# Scheduling & Dispatch

## Proposed Changes for Battery Storage Units

Modifications Committee

19 October 2023

# Registration as Part of a Trading Site

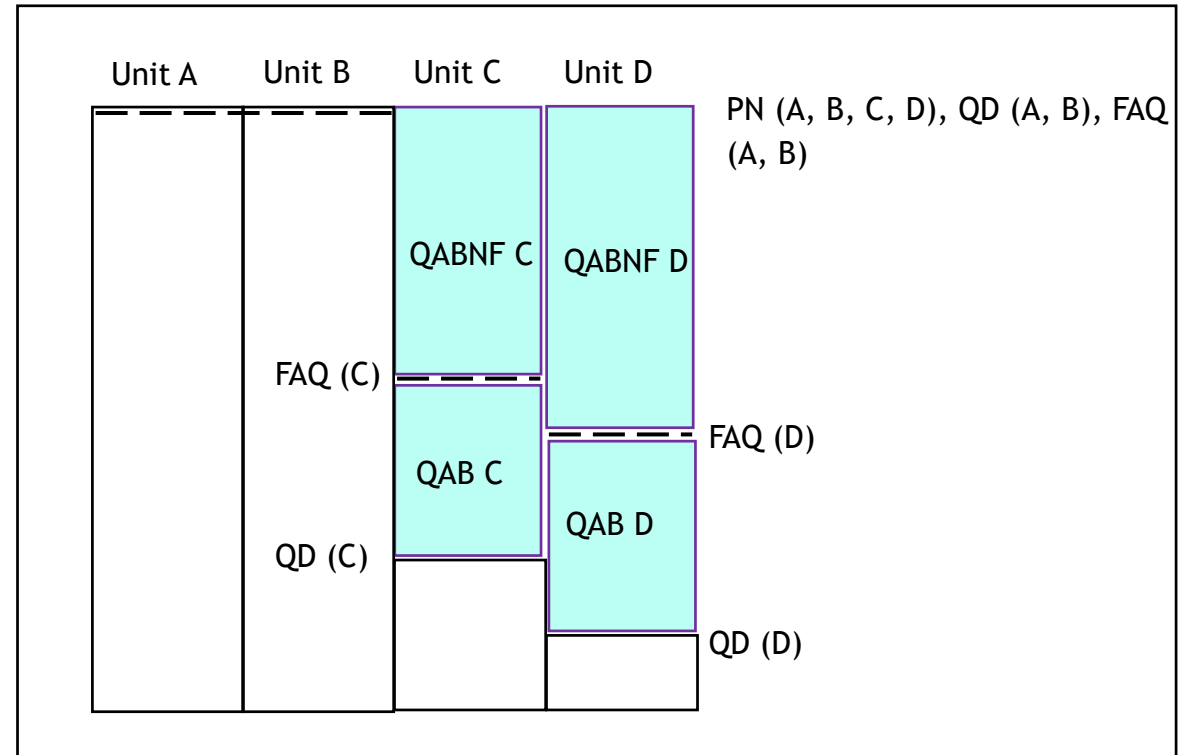
- Battery Storage Units will be required to register as part of a Trading Site like other generator units.
- Previously Battery Storage Units were required not to register as part of a Trading Site to match the treatment of Pumped Storage Units.
- Non-firm quantities are calculated on a Trading Site basis, so without being part of a Trading Site non-firm quantities will not be applied to Battery Storage Units.

F.6.5.2

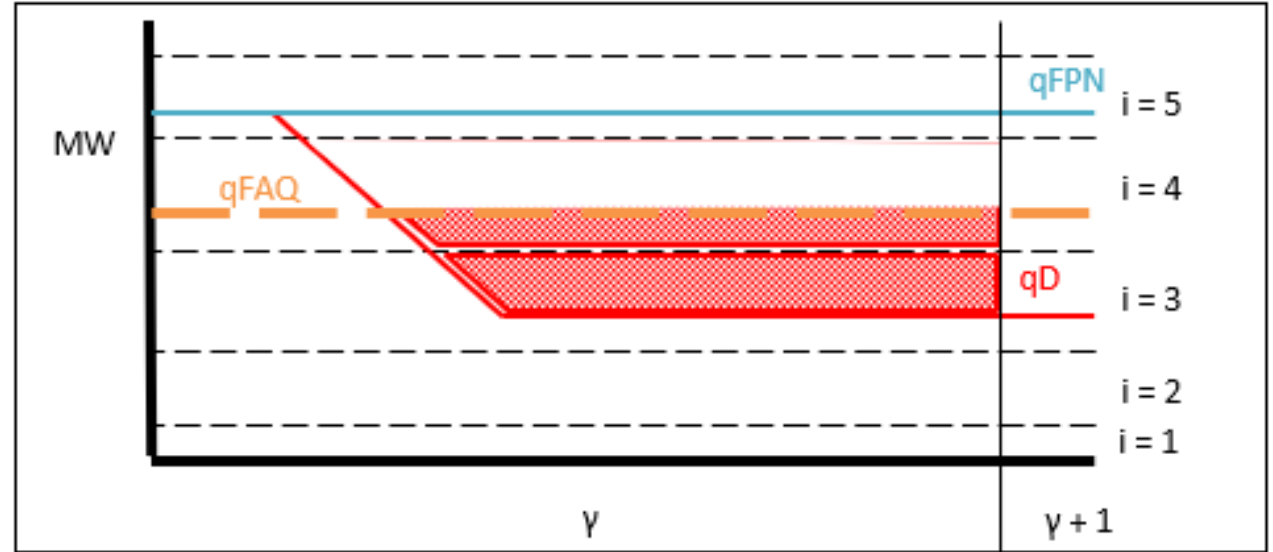
- When no dec actions are taken, Unit Firm Access Quantity qFAQ always = FPN
- When dec actions ( $QAB < 0$ ) are taken on the single unit Trading Site:

If FPN  $\geq 0$ :

Unit Firm Access Quantity qFAQ = FPN - non-firm portion of FPN = Trading Site FAQ

If FPN  $< 0$ :

Unit Firm Access Quantity qFAQ = Max(negative - positive, 0) = 0

# Commercial Offer Data

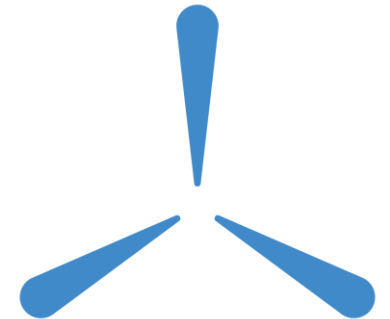
- *Additional fields for battery storage units:*
  - Operational Minimum Storage Quantity (MWh)
  - Operational Maximum Storage Quantity (MWh)

These fields will allow a warning to be provided to the control centre if Physical Notifications submitted by a participant for a battery unit cause the unit's storage level to fall outside of these operational limits.

- *Forecast Minimum Stable Generation:*
  - To be mandated to be submitted as zero for all imbalance settlement periods.
  - This will allow unit to be synchronised to import or export.

### F.6.2.4

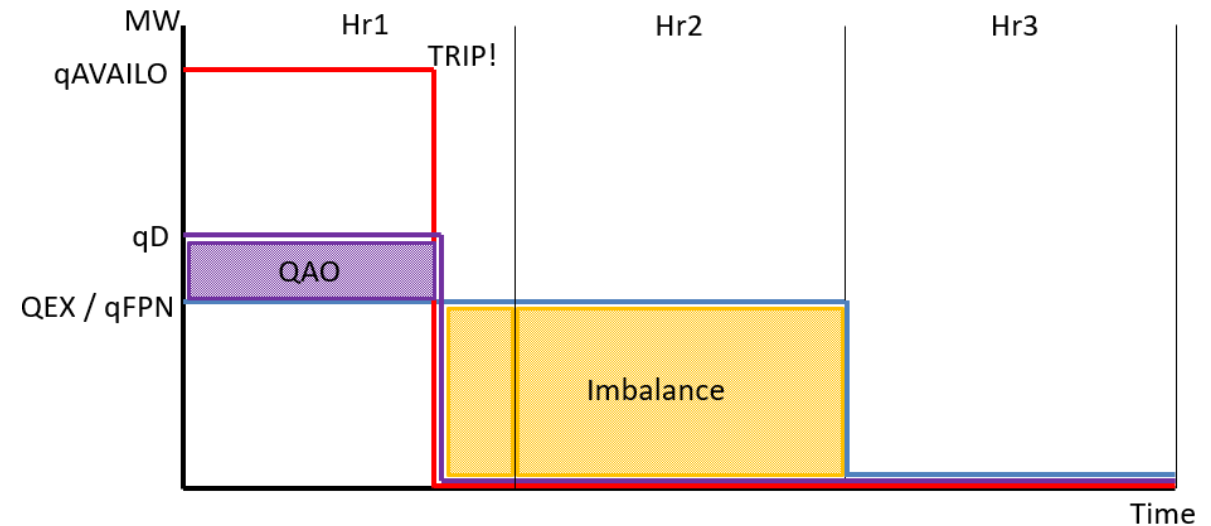
- At present Outturn Availability is included in the algebra for calculating Accepted Bid Offer Quantities for decs to ensure that any decrease in output from PNs due to reduced availability is seen as an imbalance, rather than an Accepted Bid:
